Access Compliance Report

Public Rights-of-Way

| Intersection ID: 46491 | Main Street: BERE_ISLAND_DR | Cross Street: CASTLECOVE_RD | Location: SE |
| ADA ID: A10C18A9C141 | Ramp Type: PerpDiag | Initial Pass/Fail: Fail | Overall Compliance: No |

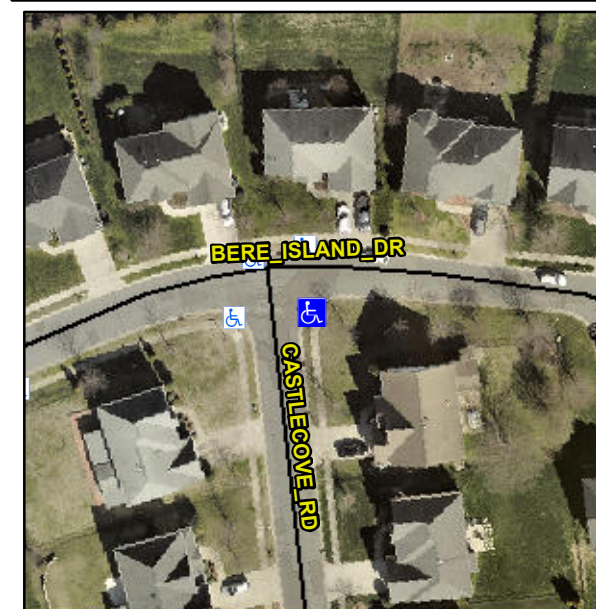
Not Found, R304.5.1, R304.2.2, R304.5.3

| Compliance | Description | Data | Compliance | Description | Data |
|------------|-----------------------|------|------------|-----------------------------|------|
| N/A | Ramp Length (in) | 48.0 | No | Ramp Slope (%) | 11.4 |
| No | Ramp Width (in) | 46.5 | No | Ramp XSlope (%) | 2.2 |

Remove & Replace Curb Ramp With Two New Directional Ramps or Equivalent.
